DEPARTMENT OF CIVIL ENGINEERING

The Amt. Z.P.Shikshak Sahakari Bank Ltd. Amravati R. No.116

Subject: Structural audit of Head Office Bank Building at Amravati

Photo 12: Crack Lintel Beam

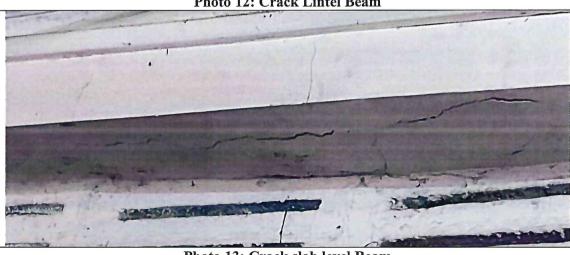
- The heavy dampness can be seen in right hand side of wall from inside as well as i. outside. This wall is load bearing. Due to dampness the plaster from inside & outside is started falling down. Please refer Photograph No. 2,3,4 & 5.
- ii. The chajjas from both side and on all floors are deteriorated badly. Bottom concrete cover is falling down and reinforcement exposed at many locations. At one location chajja is completely fall down. Please refer Photograph No. 6,7 & 8.
- iii. The outside columns are cracked. Please refer Photograph No. 9 & 10.
- iv. Some of the beams are cracked. Please refer Photograph No. 11, 12 & 13.
- Dampness in slabs at some location is observed. Also, concrete cover falls down and reinforcement exposed. Please refer Photograph No. 14, 15 & 16.

- i. From visual inspections, it is observed that condition of building is deteriorated. Cracks are developed in structural members like columns & beams.
- ii. Dampness is observed in right side load bearing wall which carrying the half load of the building. Falling of plaster and concrete cover of structural elements are warning before failure.
- iii. UPV test indicates that concrete quality of structural members is poor.
- iv. The results of rebound hammer test indicate that the concrete strength is moderate (but not good).
- v. <u>It is concluded that the durability and stability of existing building is poor as it is showing all indications before major failure.</u>
- vi. <u>It is recommended to demolish the building to the earliest to avoid any major mishap.</u>

Photo 19: Rebound Hammer Test on Beam

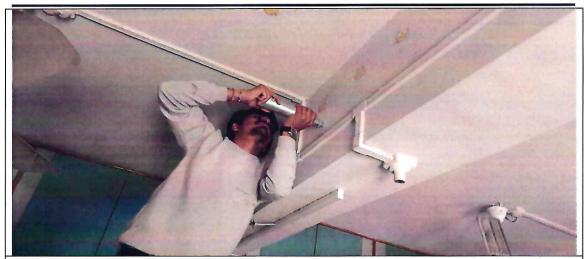
After visual inspection NDT had been carried out to decide the quality of existing concrete, by ultra sonic pulse velocity test (UPV) as per IS 516 Part 5 2018 and rebound hammer as per IS 516 Part 4 2019. The photographs 17, 18, 19 & 20 show NDT on site. The UPV test & rebound hammer test conducted on columns, beams and slabs on every floor after selecting them randomly. The results of test are presented after photographs.
